ArevaEPRDCPEm Resource

From: Pederson Ronda M (AREVA NP INC) [Ronda.Pederson@areva.com]
Sent: Friday, November 06, 2009 9:58 PM
To: Tesfaye, Getachew
Cc: MCINTYRE Brian (AREVA NP INC); DELANO Karen V (AREVA NP INC); SLIVA Dana (AREVA NP INC); WILLIFORD Dennis C (AREVA NP INC)
Subject: Response to U.S. EPR Design Certification Application RAI No. 273, FSAR Ch. 11, Supplement 1
Attachments: RAI 273 Supplement 1 Response US EPR DC.pdf

Subject: Response to U.S. EPR Design Certification Application RAI No. 273, FSAR Ch. 11

QUESTIONS for Health Physics Branch (CHPB)

Figure 11.2-2—Liquid Waste Processing System, Evaporator System

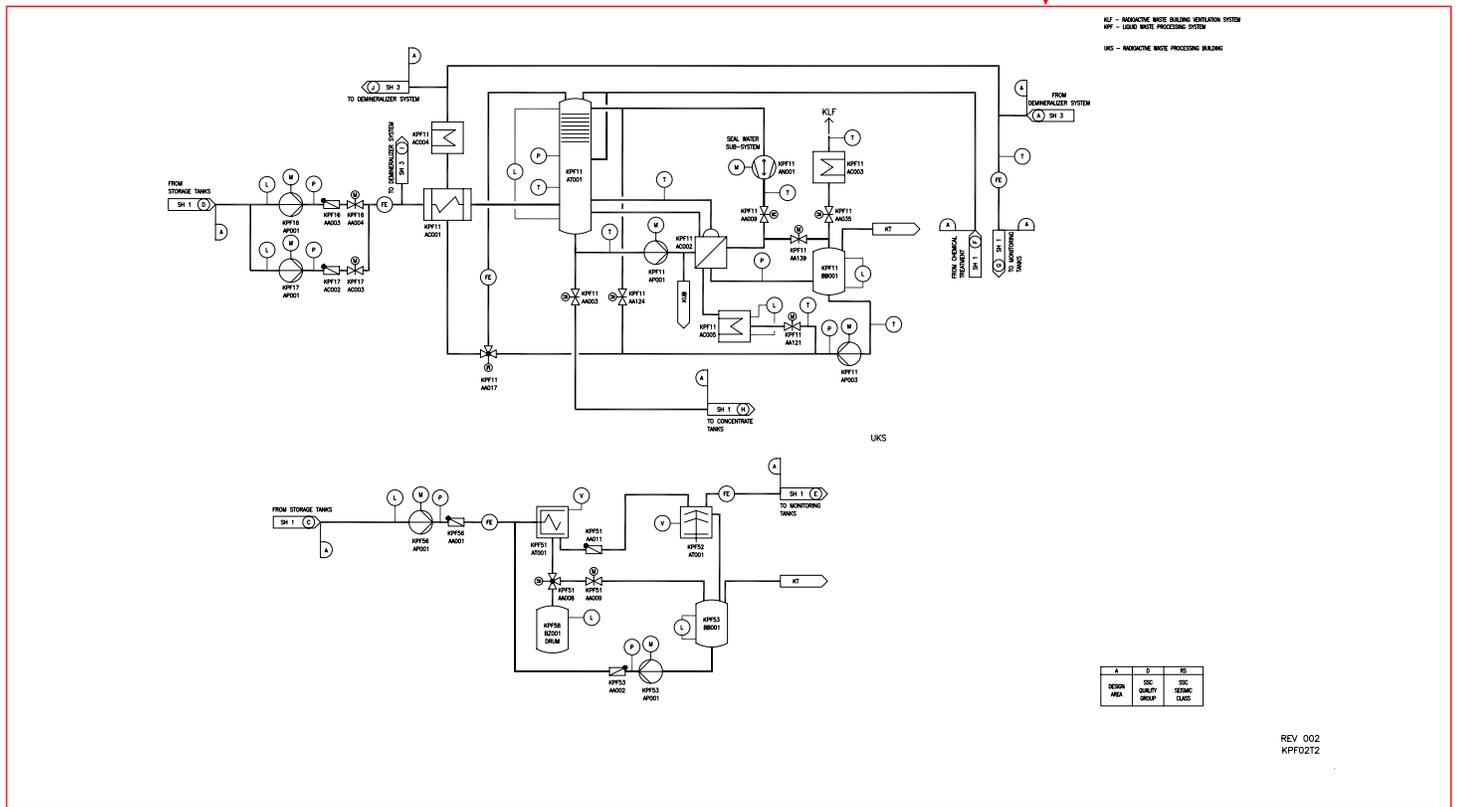
In Section 11.2.2.3, the FSAR describes a process by which radioactive process and effluent samples will be collected from various segments of the LWMS. However, a review of FSAR Figures 11.2-1 to 11.2-3 reveals that there are no sampling points identified in LWMS subsystems. A review of FSAR Tier 1, Figure 1.3-1 and FSAR Tier 2, Figure 1.7-1 indicates that there are no P&ID symbols for sampling points. Accordingly, the LWMS P&ID drawings and supporting legends in FSAR Tier 1 and 2 figures should be revised to include the locations and identification of sampling points in all associated LWMS subsystems.

- 3) The drawing for the centrifuge shows that two tanks are connected to the system for the collection of solids and sludge, but the text refers to drums being used for that purpose. The drums or connections to replaceable drums are not shown in the drawing.

U.S. EPR FSAR Tier 2, Figure 11.2-1 and Figure 11.2-2 will be revised to show the location of sampling points (KUB connectors) in the liquid waste management system (LWMS), which denote local grab samples.

- 1) Ventilation lines will be added to U.S. EPR FSAR Tier 2, Figure 11.2-1 to show connections to the radioactive waste building ventilation system (RWBVS) (system identifier of KLF) from the liquid radwaste storage tanks, as described in U.S. EPR FSAR Tier 2, Section 11.2.3.6.
- 2) U.S. EPR FSAR Tier 2, Section 11.2.2.4.1 will be revised to remove the number and types of connections for the storage tanks, concentrate tanks, and monitoring tanks. This will provide consistency between the text and the figures.
- 3) No “drum” symbol is available in the simplified list of symbols in U.S. EPR FSAR Tier 2, Figure 1.7-1. Equipment tag KPF58 BZ001 is the drum discussed in U.S. EPR FSAR Tier 2, 11.2.2.4. The word “DRUM” will be added to the label for this equipment in U.S. EPR FSAR Tier 2, Figure 11.2-2 for clarity.

11.02-7 & 11.02-9

Figure 11.2-3—Liquid Waste Processing, Demineralizer System

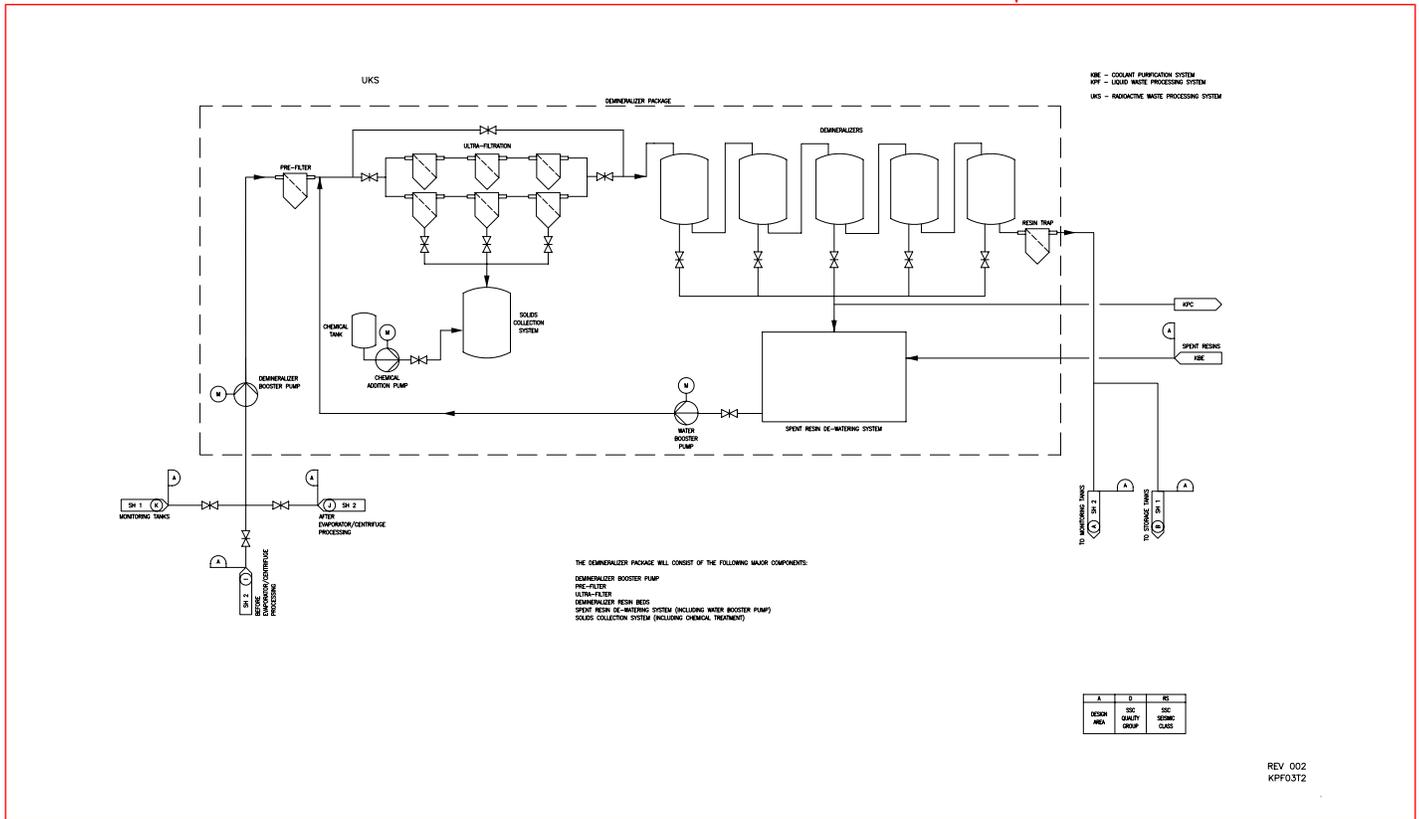
In Section 11.2.2.2.3 and Figure 11.2-3, the FSAR describes the demineralizer subsystem and states that the inlet to the subsystem is equipped with prefilters to remove fine particles. A review of the drawing indicates that there are no filters to remove resin fines out of the demineralizers before sending process waste streams to the monitoring tanks for release to the discharge canal. Without resin traps in the outlet stream of the demineralizer, there is the possibility that high radioactivity resin fines could be discharged in the environment. Accordingly, the applicant should review the design and consider the installation of resin traps on the discharge line after the last demineralizer column so as to not exceed effluent concentration limits of Appendix B to Part 20 during releases via the LWMS discharge line.

- 4) The level of details and description of components for the demineralizer system is inconsistent with the corresponding drawings for the other subsystems. The drawing also shows components that are not described in the text, e.g., chemical additive system, and the text describes components that are not shown in the drawing, e.g., spent resin drying subsystem.

The design has been modified to add a resin trap in the outlet stream of the demineralizer. U.S. EPR FSAR Tier 2, Section 11.2.2.2.3 and Figure 11.2-3 will be revised to reflect this addition.

A footnote will be added to U.S. EPR FSAR Tier 2, Figure 11.2-3 to indicate that the demineralizer package consists of the following major components: demineralizer booster

11.02-8 & 11.02-15
